## Vivian Silica Sand Project

**Expert Report on the Sio Silica Proposed  
Vivian Silica Sand Project**

The Rural Municipality of Springfield, Manitoba

## Executive Summary

Figure 9. Scatterplot for the steady-state model calibration  
Adapted from AECOM (2021b; Figure 6-2)

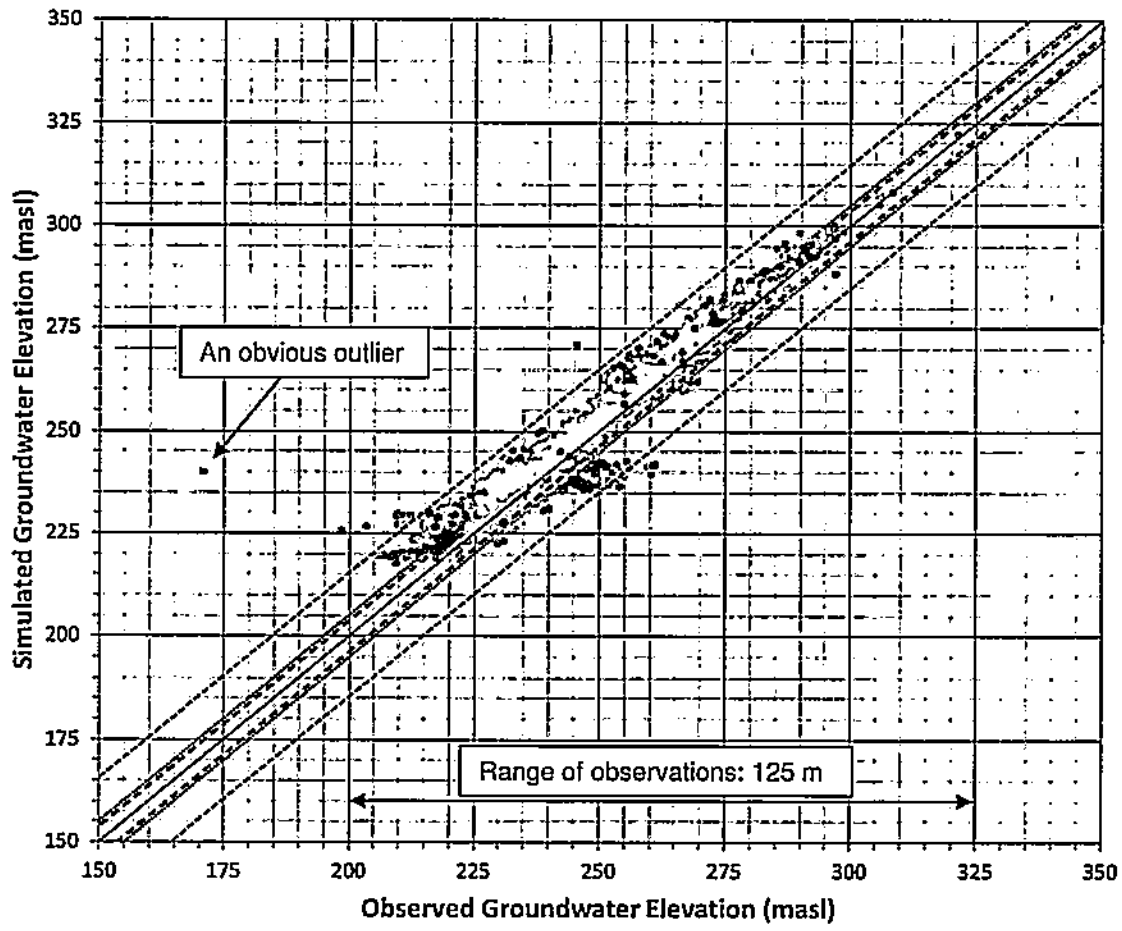
18. A scatterplot comparing the model results against the targets for the steady-state calibration is presented in Figure 6-2 of the Hydrogeology and Geochemistry Assessment Report and reproduced here in Figure 9. In my opinion, the scatterplot does not provide a convincing demonstration that the model has been adequately calibrated. I base my opinion on the following observations.

- No distinction is made between the reliability of the water levels that are used as targets. Average water levels estimated for dedicated observation wells installed for the project and the wells from the Manitoba Provincial Monitoring Program should be assigned higher weights in the calibration. In terms of the graphical presentation, the symbols for these wells should be prominent.

- As shown in Figure 9, the model exhibits a clear bias to overpredict water levels. The mean residual is 3.27 m.
- As indicated by the red dashed lines added in Figure 9, at the location of any particular target it appears that the mismatch of the model is likely on the order of  $\pm 15$  m. It may be debated that the Root Mean Square Error (RMSE) is a better measure of the local mismatch than the range of the errors estimated here by eye. Acknowledging this, it is still important to note that for this model the RMSE of 5.46 m is relatively large compared to the anticipated effects of the proposed operations.

- Although the Normalized Root Mean Square Error (NRMSE) is frequently adopted as a measure of the model goodness-of-fit, it is important to note that it is open to mis-application. In particular, the value of the NRMSE depends on the interpreted range of the observed water level targets. The NRMSE is defined as:

Noting that the reported RMSE is 5.46 m and the reported NRMSE is 1.70%, the back-calculated Range of Observations is 321.2 m. As shown in Figure 9, the range of the observations is more likely 125 m. With this range the NRMSE is re-calculated as 4.3%.

Figure 10. Detail of calibration residuals near Winnipeg  
Excerpt from AECOM (2021b; Figure 6-3)

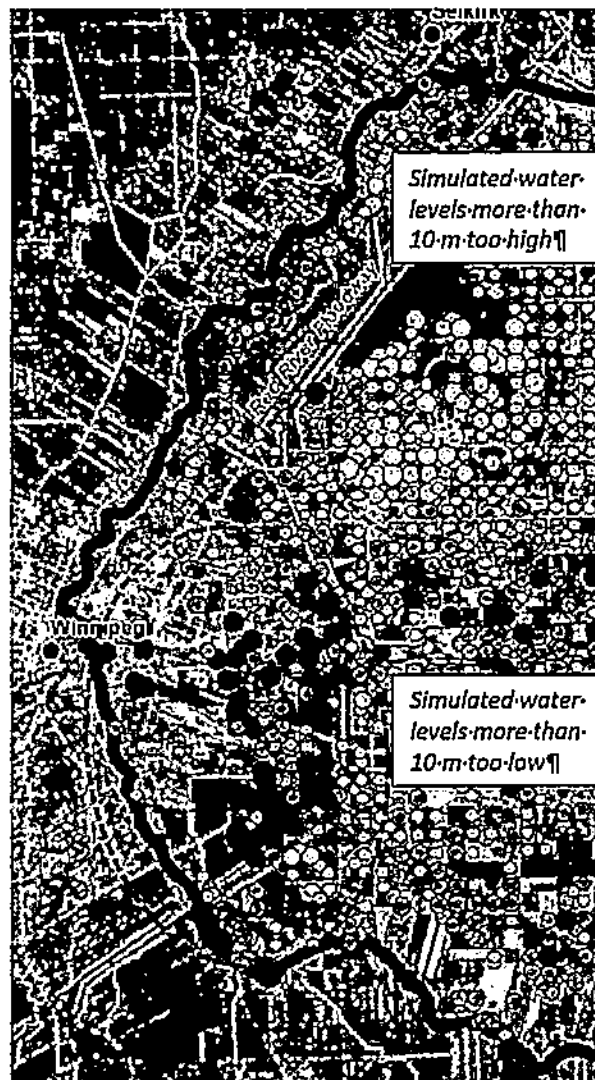
19. It is indicated on Page 72 the Hydrogeology and Geochemistry Assessment Report that at lower elevations, the calibrated steady-state groundwater model simulates groundwater levels that are higher than observed. The mismatch near Winnipeg is attributed to increased groundwater use in the area east of Winnipeg that is not accounted for in the modelling analysis. Based on my examination of Figure 6-3, the mismatch along the Red River is more suggestive of a problem with the model structure. As shown in the excerpt from Figure 6-3 shown here in Figure 10, there is an area close to Winnipeg where the simulated water levels are more than 10 m lower than observed (red circles; observed – simulated > 10 m). North of this area there is an area close to Red River Floodway where the simulated water levels are more than 10 m higher than observed (pink circles; observed – simulated < - 0 m). The large positive and negative residuals suggests that the boundary conditions may not be assigned appropriately.

Figure 11. Comparison of observed and simulated drawdowns for the Bru 95-7 pumping test

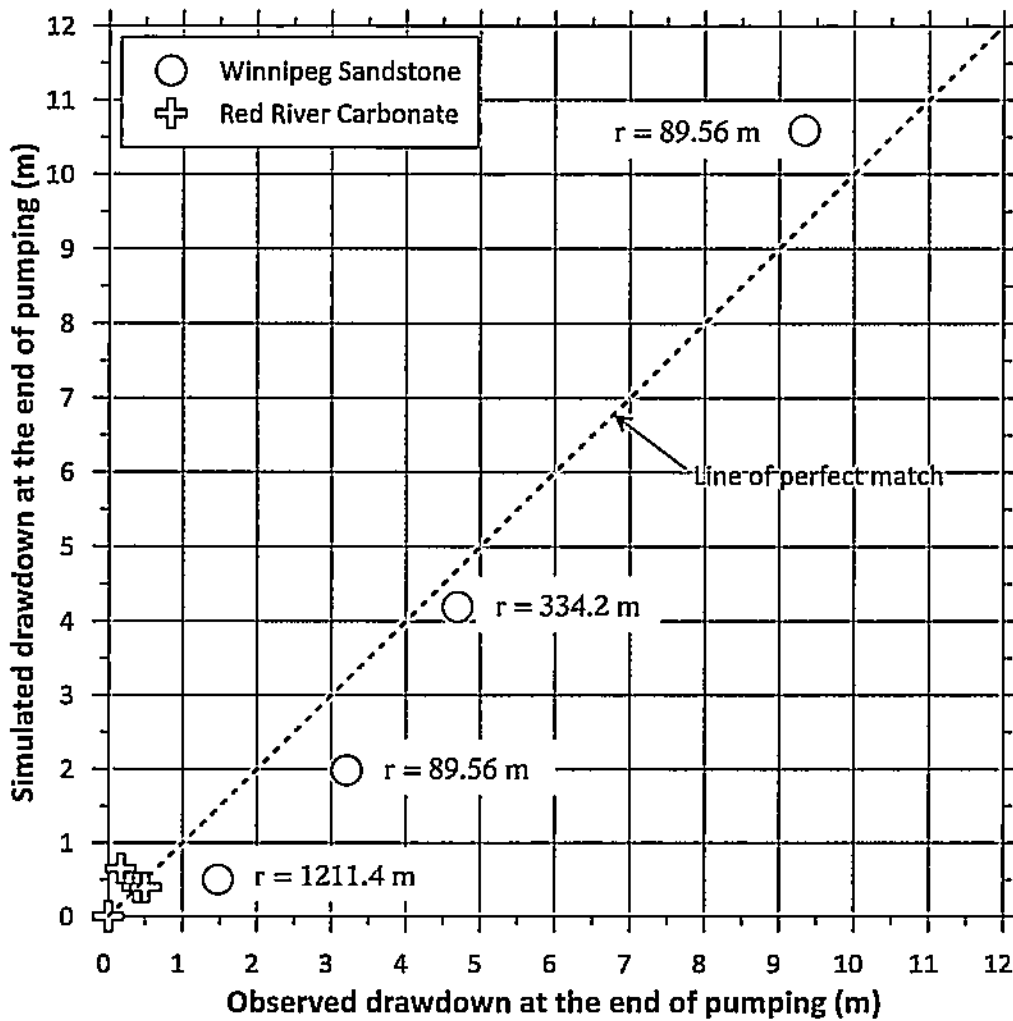
20. It is indicated on page 73 of the Hydrogeology and Geochemistry Assessment Report that at distances greater than 300 m the groundwater model simulates smaller drawdowns than were observed during the pumping test. This is highlighted in the comparison between observed and simulated drawdowns at the end of the pumping test. The drawdowns have been estimated from Figure 6-4. The results shown here in Figure 11 suggest that there is a systematic underestimation of the drawdowns at more distant locations in the Winnipeg Sandstone. This has important implications with respect to the impact assessment, as it is an indication that potential impacts on neighboring private wells may be underestimated.

Figure 12. Summary of hydraulic conductivity estimates

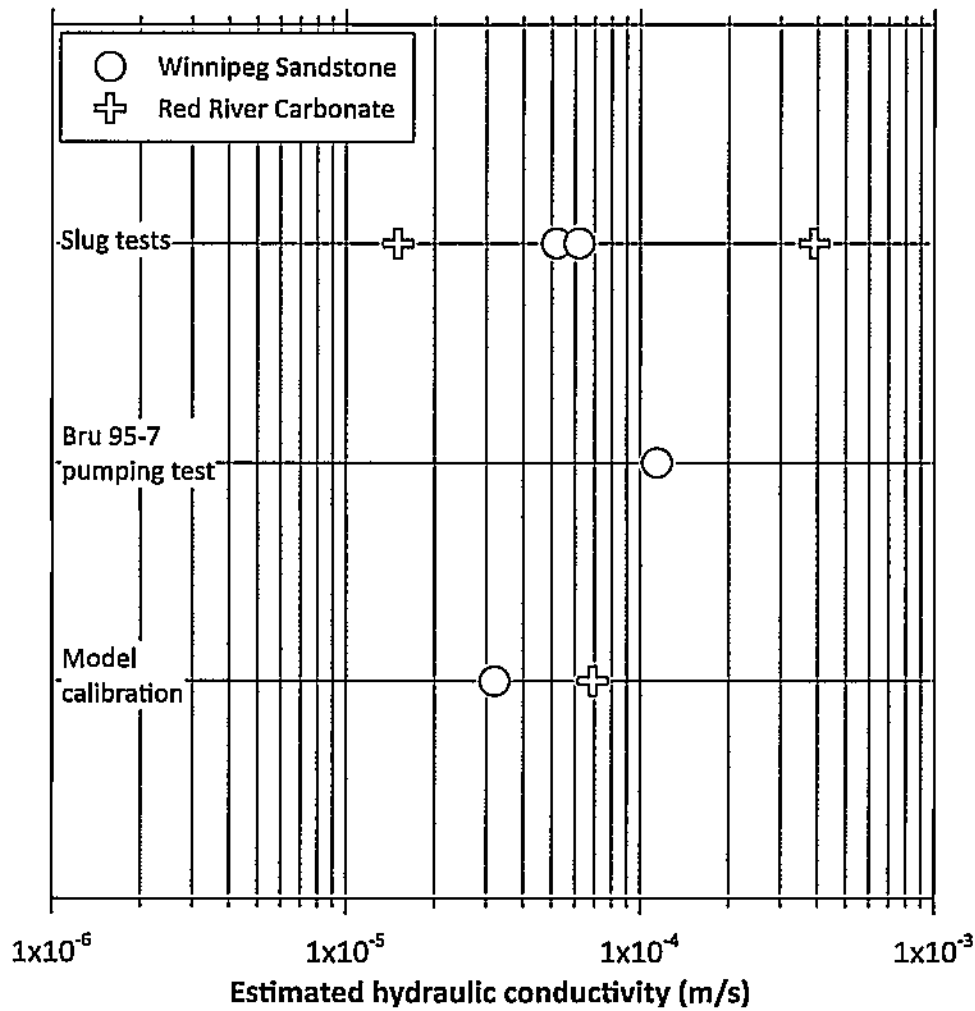
21. Limited data are available to assess whether representative values of the hydraulic conductivities of the Winnipeg Sandstone and the Red River Carbonate have been inferred through model calibration. As shown here in Figure 12, although the value of the hydraulic conductivity of the Winnipeg Sandstone specified in the groundwater model is consistent with the estimates obtained from the two slug tests, it is substantially lower than the value inferred from the pumping test. The hydraulic conductivity of the Red River Carbonate specified in the groundwater model is within the range of the two estimates obtained from slug tests, but the most important conclusion that might be drawn from the comparison is that the two slug test estimates vary by a factor of about 25.

Figure 13. Well clusters activated during 2025  
Adapted from AECOM (2021b; Figure 6-5)

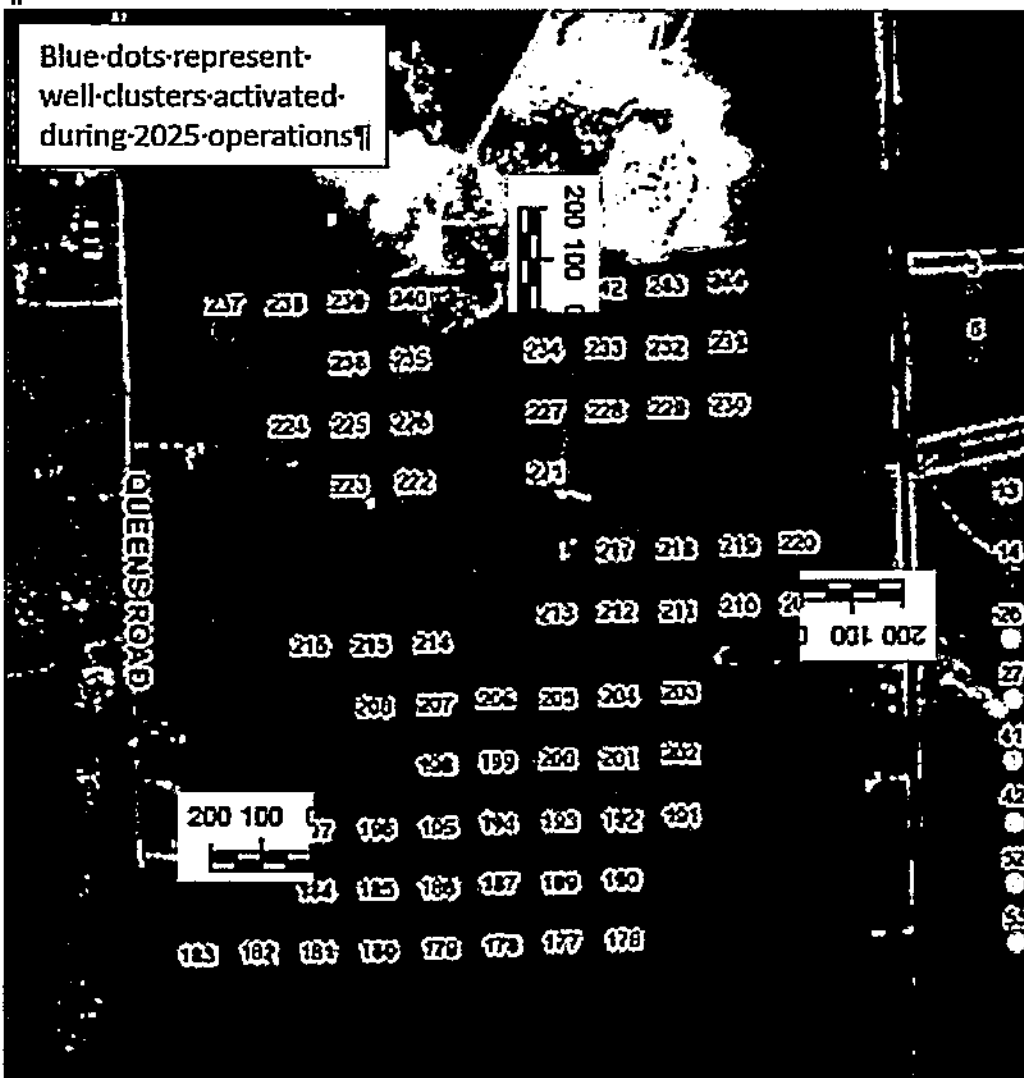
The assumption that between the voids created by mining the Winnipeg Sandstone aquifer will not be disturbed by mining and will remain intact is a very strong assumption. While there is no evidence that sand extraction will lead to widespread collapse of the Winnipeg Sandstone and the rock units that overlie it, there is no evidence that this possibility can be discounted outright. In the response to RMSF-IR-017 it is indicated that the scale of the project is regional. It is possible that the scale of the impacts of sandstone mining will also be regional in scale. In the response to RMSF-IR-005 reference is made to pilot testing. However, no descriptions of the pilot testing are presented and there are no indications as to whether displacements of rock unit were measured during the testing. Although it may not be possible to directly measure the magnitude of any change in aquifer properties prior to completion of mining, it is certainly possible to measure ground movements and changes in groundwater conditions around the site during operations.

In the response to RMSF-IR-018 it is indicated that the areas with the potential for degradation of the Winnipeg Shale are estimated to be 188 ha (Year 0) to 691 ha (Years 1 through 4), "based on the simplified assumptions taken during groundwater modelling". These areas are sufficiently large to support detailed monitoring, which is the only real way to test the assumptions incorporated in the analyses. As the center of production shifts through time, the extent of zone of degraded shale is assumed to expand. Referring to the excerpt from Figure 6-5 of Hydrogeology and Geochemistry Assessment Report shown here in Figure 13, the extent of the degraded shale is assumed to extend 200 m beyond the limits of the 2025 wells. It is indicated in the response to RMSF-IR-018 that the extent of the degraded zone will be "validated during operations". This validation will be essential to demonstrate that the effects of mining are understood, controllable and limited to the Project Site Area.

**Figure 14. Results of simplified analysis of the transient response to pumping near well 30-10-8E1**

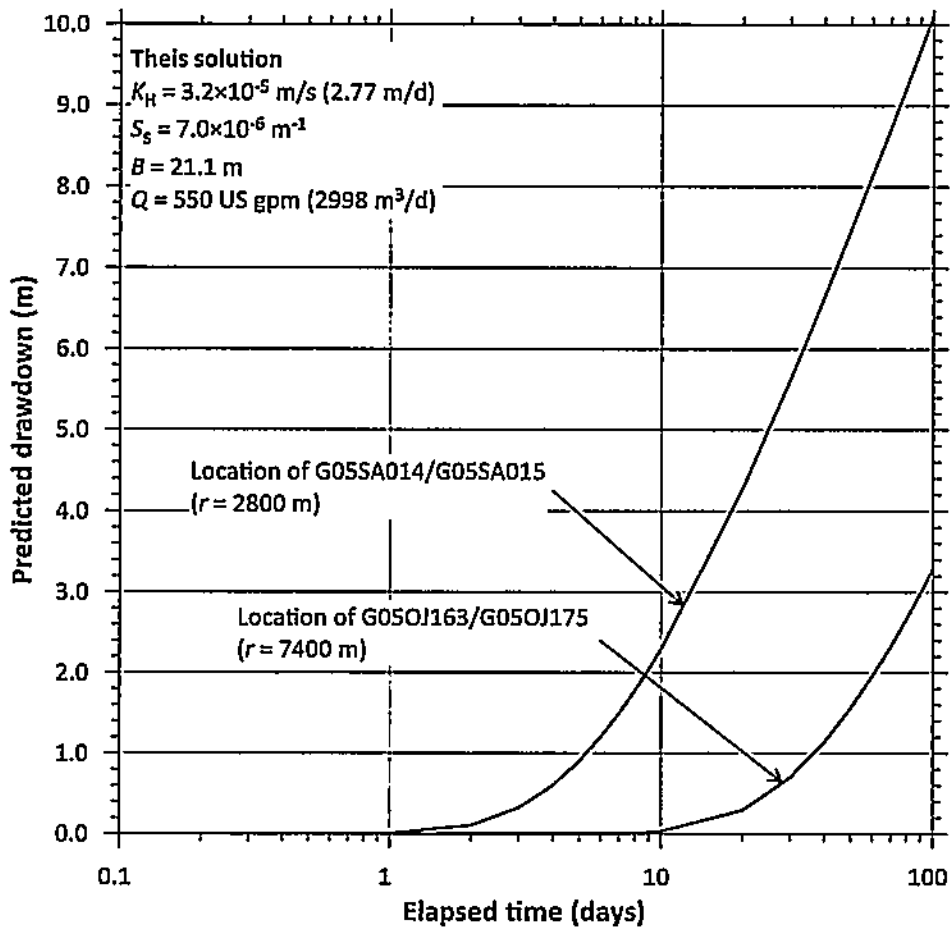
28. In theory, it should be feasible to conduct a back-of-the-envelope check on the results for the steady-state analysis of Scenario 3 (0% re-injection, no degradation of Winnipeg Shale). Referring to Table 6-1, steady-state drawdowns of 0.9 m and 0.0 are reported for G05SA014 and G05OJ163, respectively. The Theis (1935) solution is applied here with the parameter values listed on Table 6-C, assuming an aquifer thickness of 21.1 m and specifying the approximate radial distances between 30-10-8E1 and G05SA014 and G05OJ163. It is not clear why the results of the groundwater model are so much smaller than those estimated with the Theis solution. My expectation is that the steady-state analysis would provide conservative upper-bound estimates on the drawdown.
